KEIZER PLANNING DEPARTMENT NOTICE OF DECISION Partition Case 2025-16

This application requests approval to partition an existing parcel totaling approximately 18,764 square feet into two lots.

1 SITE PLAN
SCALE: 1" = 10'-0"

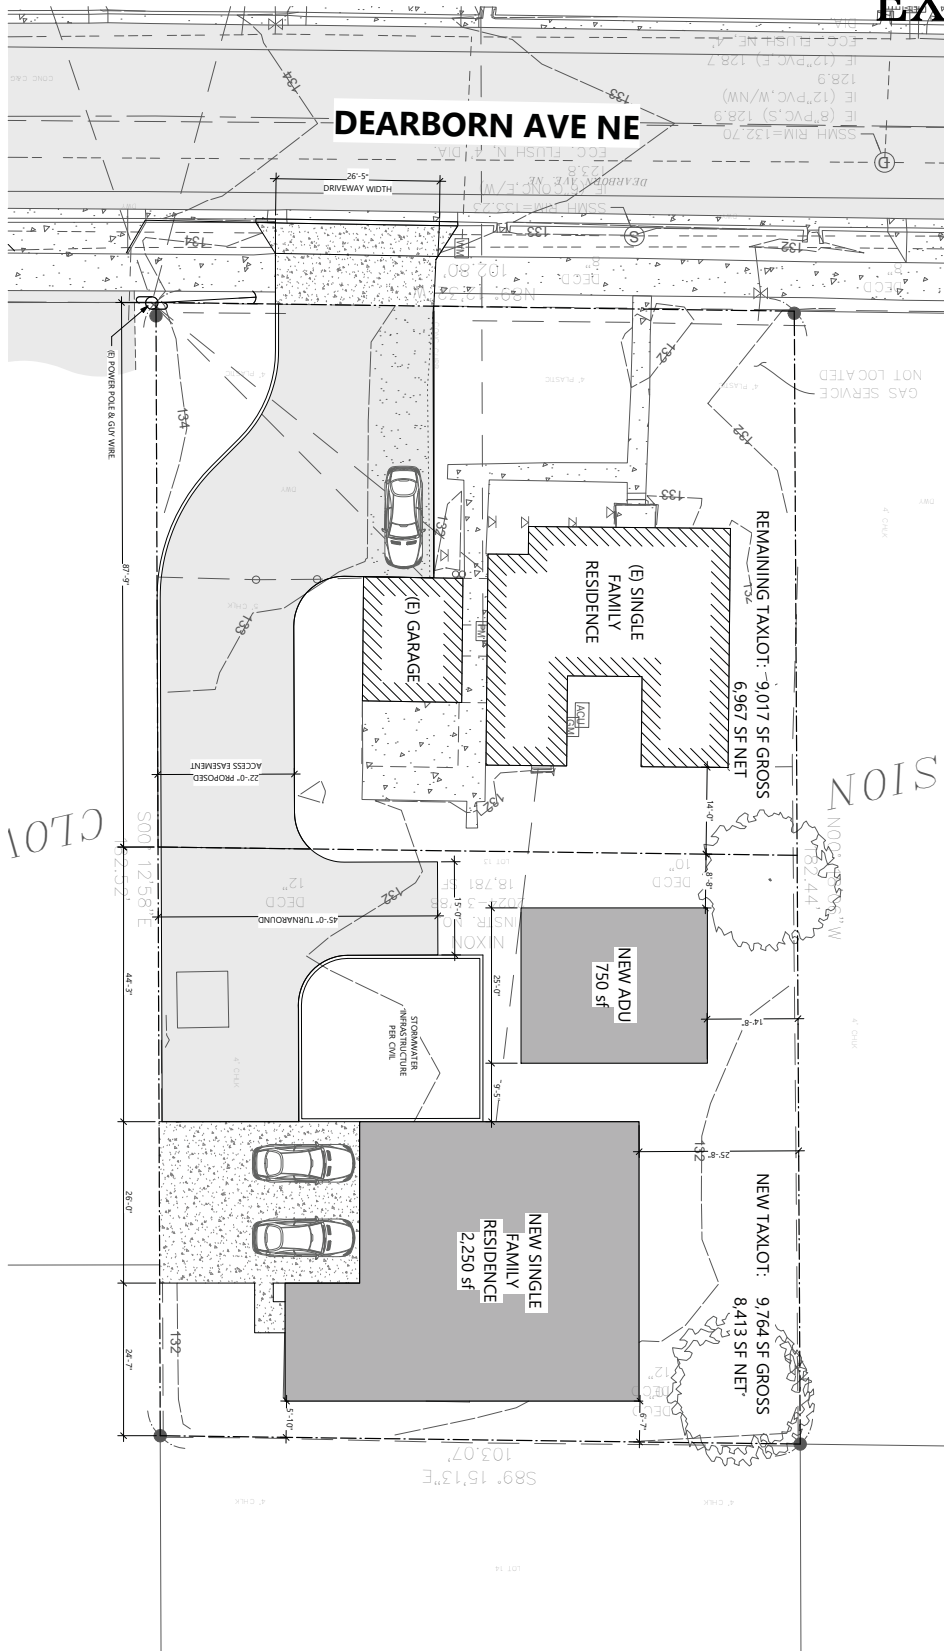
Width: The applicant's statement indicates the existing single-family dwelling will remain on Parcel 1, and a single-family dwelling with an ADU is proposed for Parcel 2. The submitted site plan shows an access easement less than 300' in length, with a width of 22'. The RS zone also requires a minimum 5' setback from the edge of an access easement to any structure. Based on this information, the proposal can comply with the applicable standards for single-family, duplex, triplex, or quadplex development. As a condition of approval, the location and dimensions of the access easement must be clearly shown on the partition plat. The easement must be fully improved prior to final plat approval, or secured through a performance bond, improvement agreement, or other form of security acceptable to the City, consistent with Sections 3.202.02.E.3 and 3.202.05.B of the KDC.

Turnaround: Since the access easement will serve two parcels, a turnaround is required. The applicant has submitted a site plan (Exhibit 1) that includes a turnaround design acceptable to the City. The final plat must depict the turnaround, which will be subject to final review by the City Engineer to ensure compliance with applicable standards.

5. Unless waived in writing by the adjacent property owners, a 6' sight-obscuring fence, wall, or hedge is required along the east side of the access easement to provide screening to the adjacent properties. If waived, documentation must be submitted to the City of Keizer Planning Department.
